ADDENDUM 1
TO
SPECIFICATIONS, BID AND CONTRACT DOCUMENTS

1st Street SE Revitalization

CITY OF Paris, TX

MTG NO. 246035

SOUTH VAULT PLANS & SECTIONS

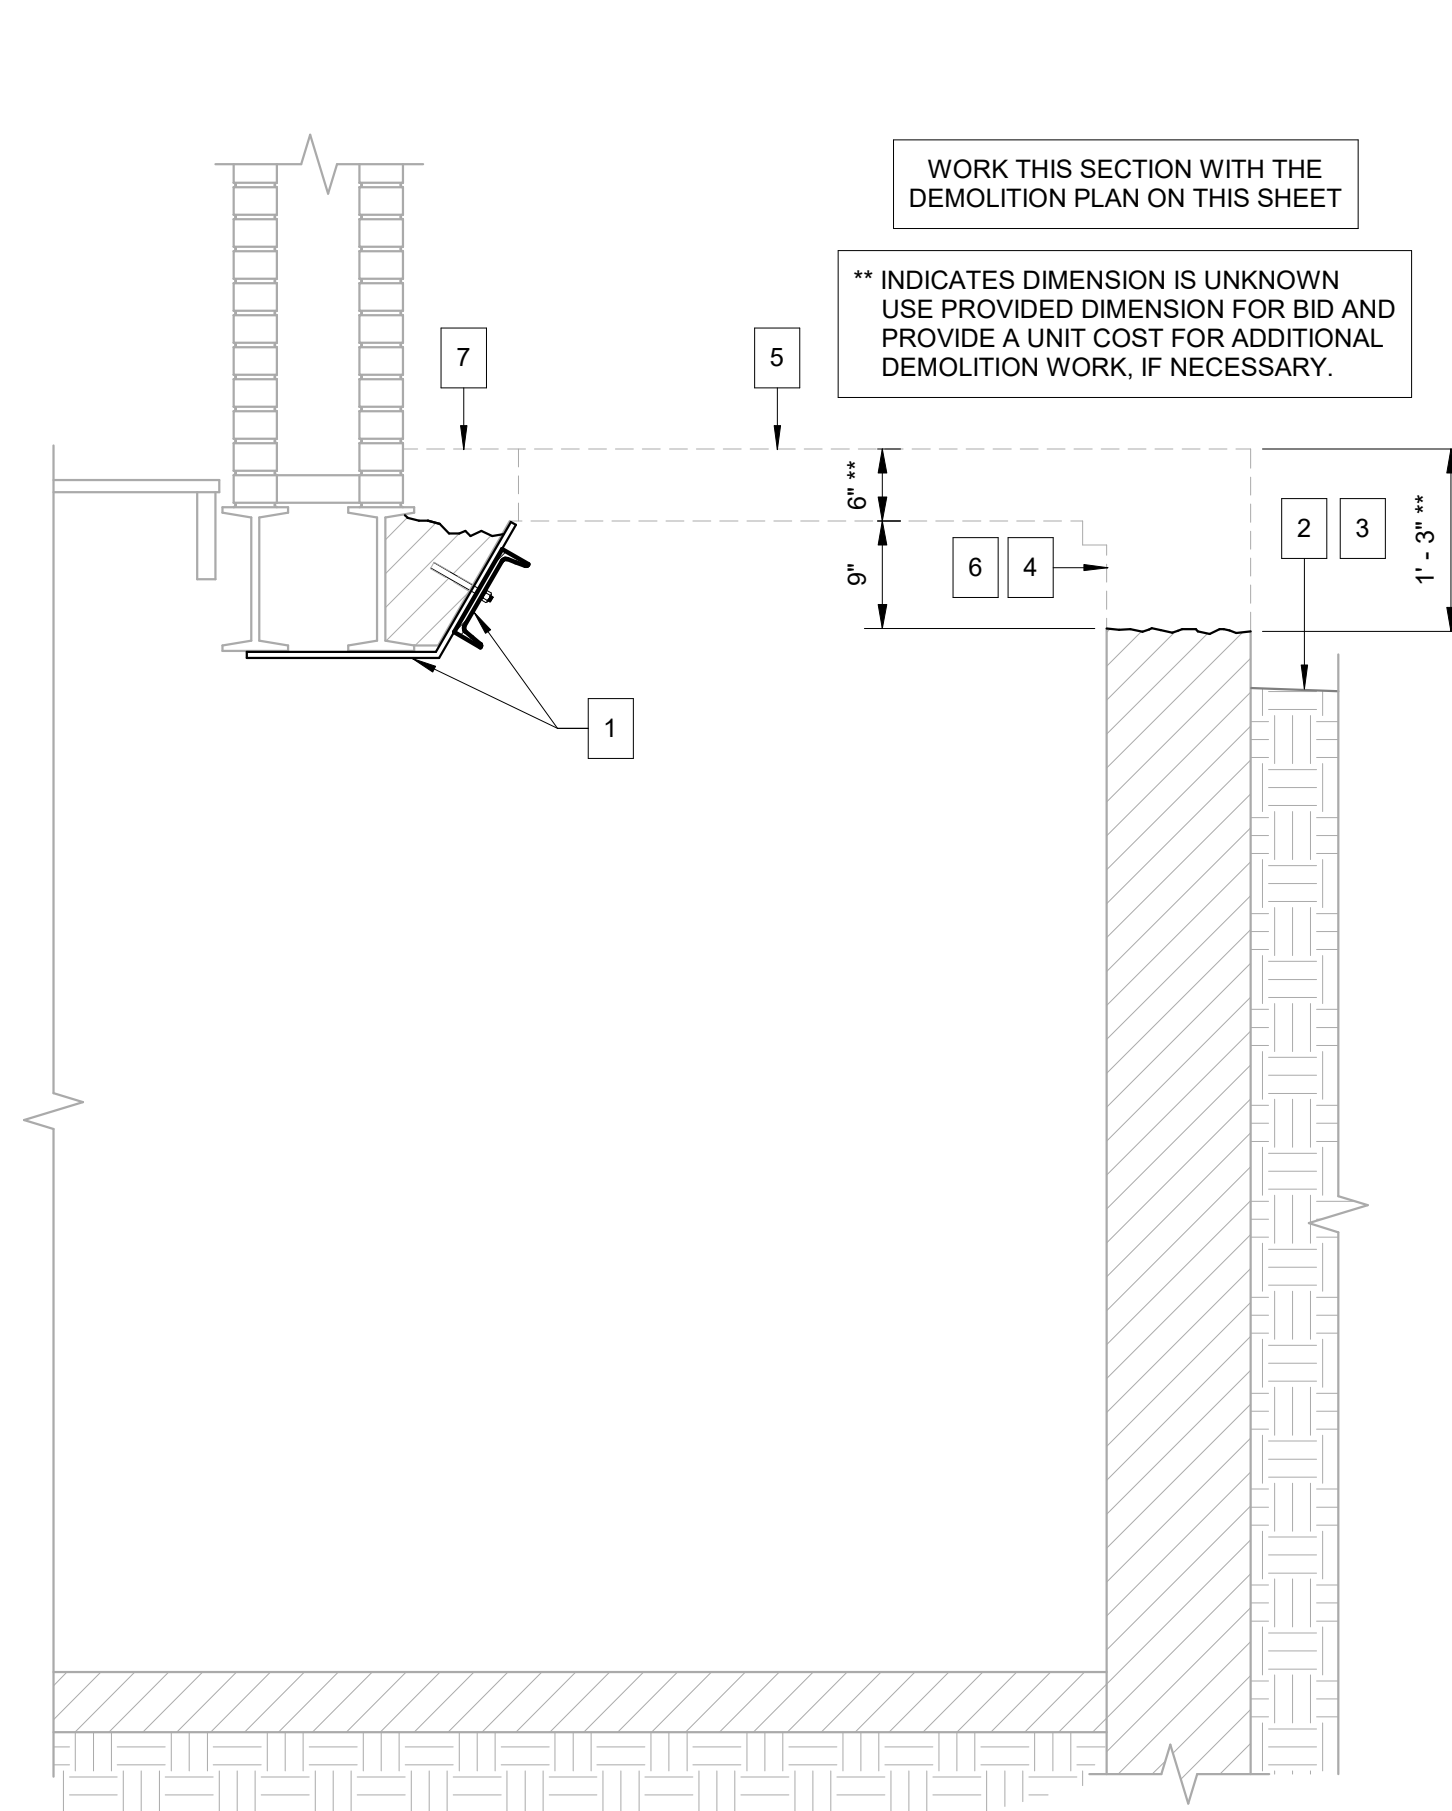
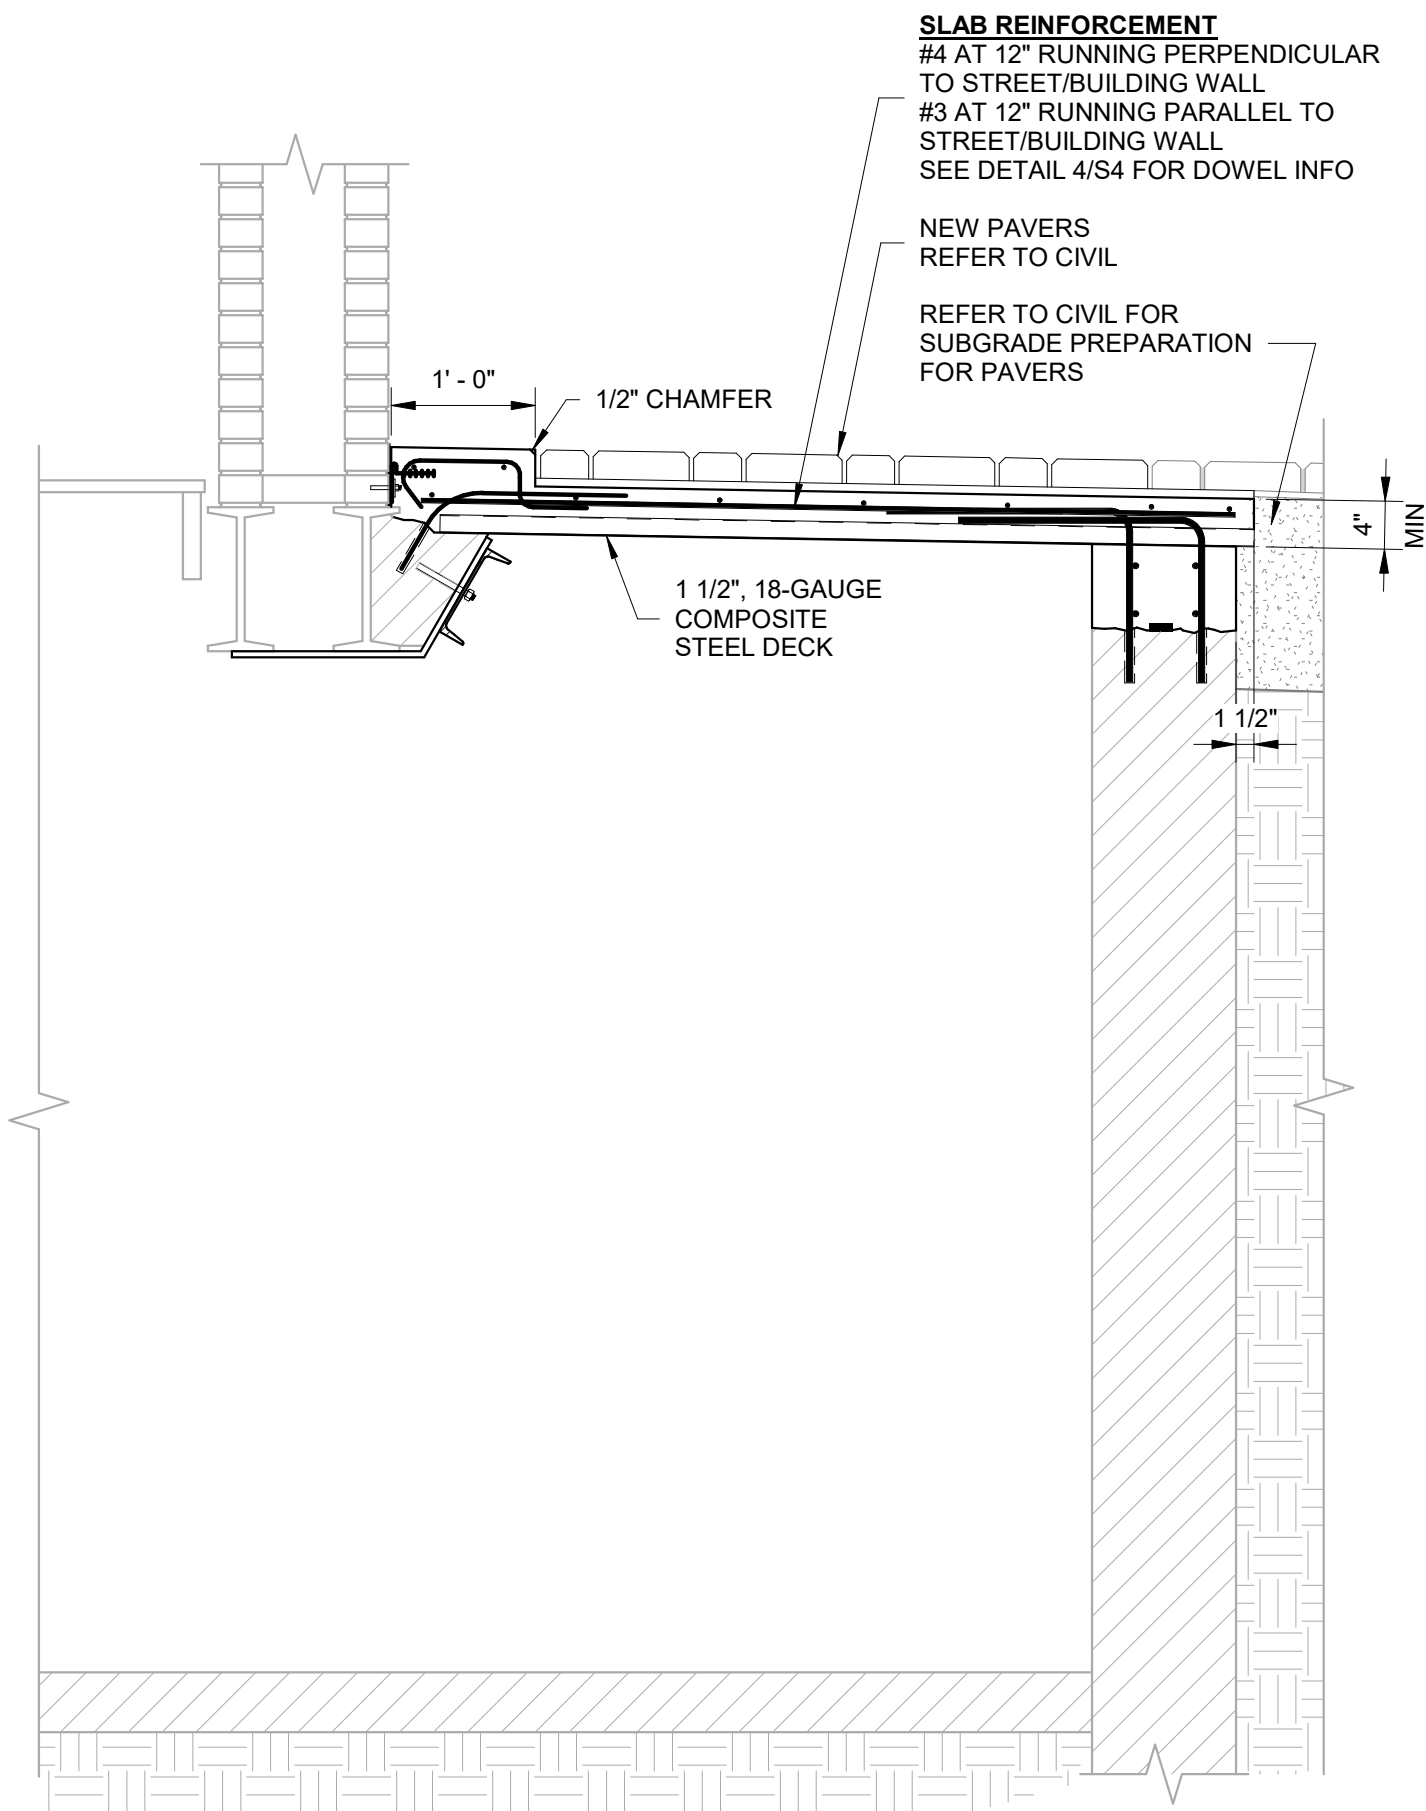
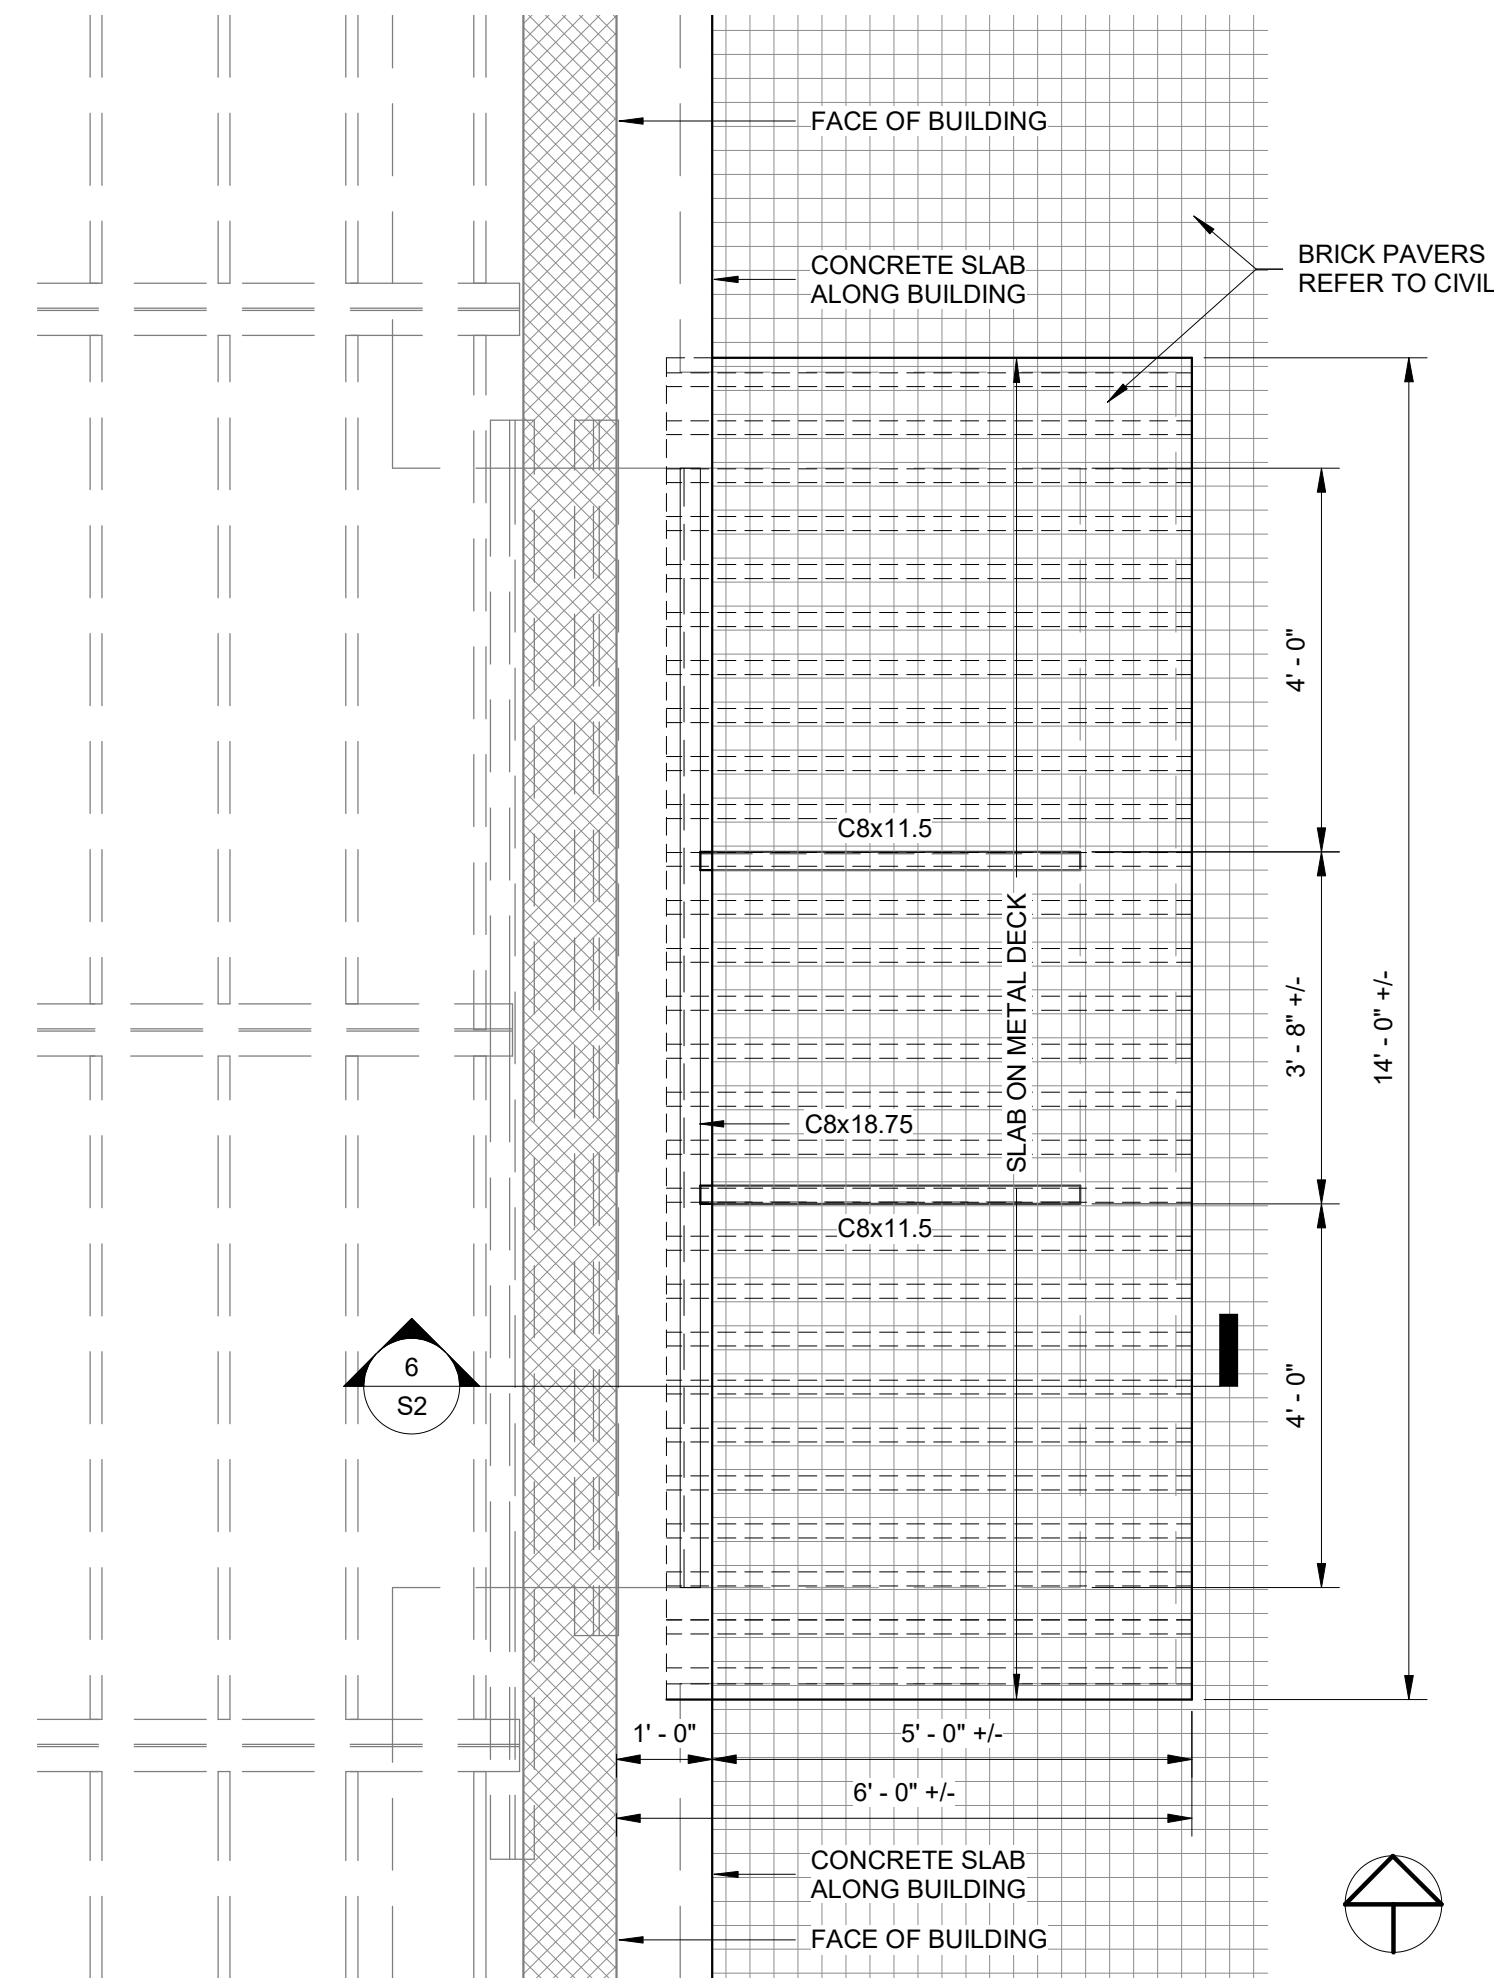
AD-1.5 Plan sheets S1,S2,S3: Plans have been replaced with corrected documents and S4 has been added to clarify Material Type and Thickness. Please replace the previous Plan Sheet S1, S2, & S3 with the attached Plan Sheet S1, S2, S3, & S4.

- C1.3: Item 12: Structural Brick Paving: Description revised, this bid item includes all work shown on sheet S1,S2, & S3 for the two (2) Structural Vault Caps. Brick Paver Furnish and install not included in this Lump Sum Item**

- C1.7: Structural Steel Members Are not required to be stainless or galvanized unless otherwise stated in plans. Galvanized Bent Plate is Preferred.**
